POINT VICENTE INTERPRETIVE
CENTER EXPANSION
31501 Palos Verdes Drive West
Rancho Palos Verdes, CA

Irrigation Plan

L-2
11 OF 69 SHEETS

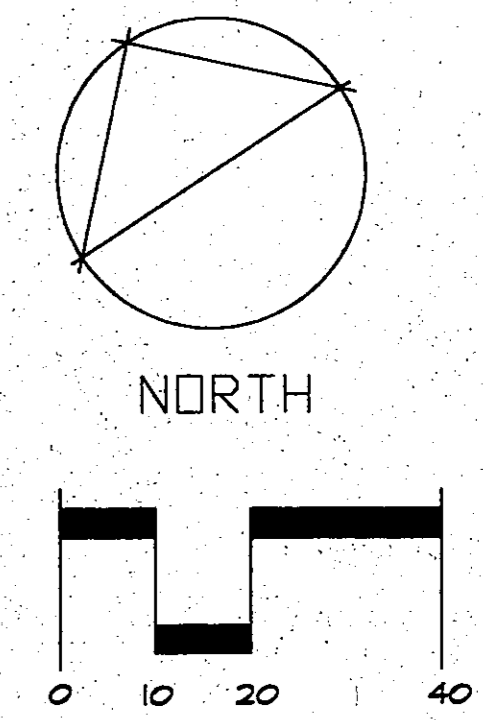
Quick Coupler (RFI 80)
